Comhairle Chontae Atha Cliath Theas

Record of Executive Business and Chief Executive's Order

Reg. Reference: SD21A/0167

Submission Type: Significant
Additional
Information

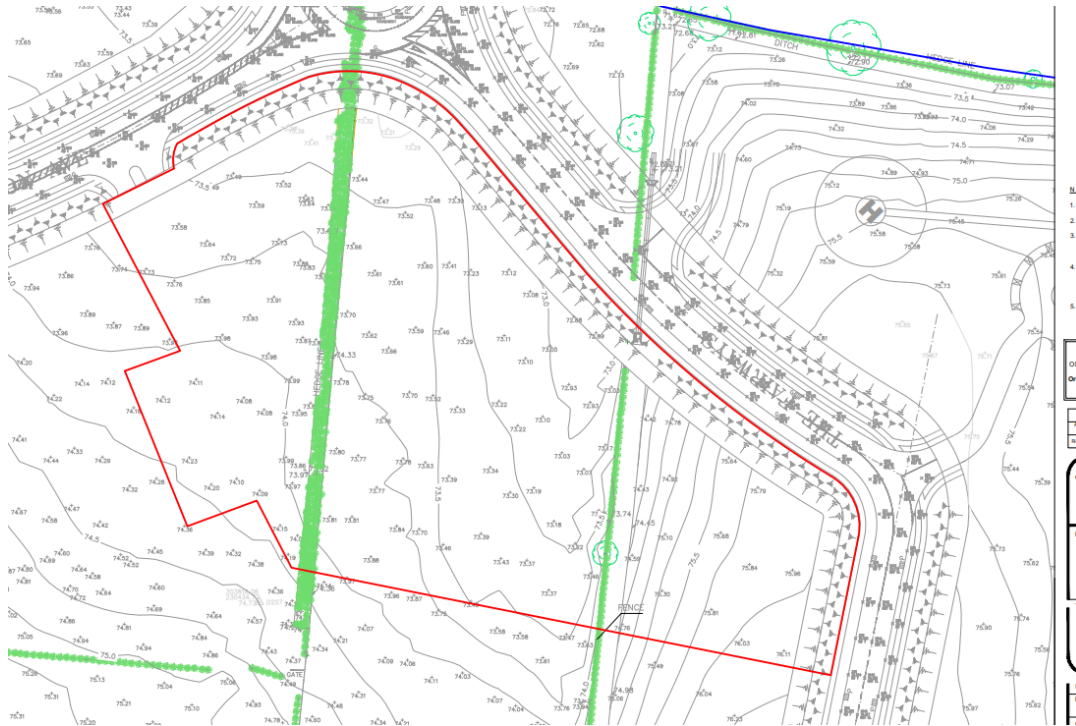
In relation to point (a) (ii) (detail on site boundary frontages) the applicant has not added any significant detail to the design of the northern frontage. It is noted that mitigation is proposed in terms of screening, however, this will take time to become established and may fail. The Planning Authority would welcome some design features to create visual interest along this elevation.

Clarification of additional information is therefore requested in this regard. It is also apparent from viewpoint 3 that changes in colouring and landscaping have been relied upon for mitigation. Again, the Planning Authority would welcome some design features to create visual interest along these elevations. **Clarification of additional information is therefore requested in this regard.**
